PCN# : P599AAB
Issue Date : Sep. 10, 2015

Information Only Notification

This is a datasheet change:

Figure 9. Maximum Safe Operating Area

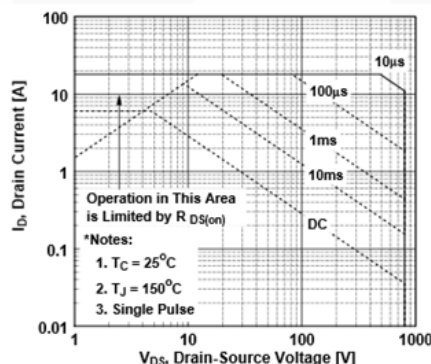
- 1) Sub Title: 800 V, 6 A, 850 m (page 1)
- 2) Absolute Maximum Ratings, Note - *Drain current limited by maximum junction temperature (page 1)
- 3) Absolute Maximum Ratings, I_D , Drain Current (Continuous $T_C=25^\circ\text{C}$) = 6 A (page 1)
- 4) Absolute Maximum Ratings, I_D , Drain Current (Continuous $T_C=100^\circ\text{C}$) = 3.8 A (page 1)
- 5) Drain-Source Diode Characteristics, I_S = 6 A (page 2)
- 6) Current Figure 9, Maximum Safe Operating Area (page 4)
- 7) Current Figure 10, Maximum Drain Current vs Case Temperature (page 4)

- 4) Absolute Maximum Ratings, I_D , Drain Current (Continuous $T_C=100^\circ\text{C}$) = 5.1 A (page 1)
- 5) Drain-Source Diode Characteristics, $I_S = 8$ A (page 2)
- 6) Updated Figure 9, Maximum Safe Operating Area (page 4)
- 7) Updated Figure 10, Maximum Drain Current vs Case Temperature (page 4)

Drain Current values being updated as updated calculations of TO220 package with heatsink R_{thjc} support the new values as shown in updated Figures 9 and 10.
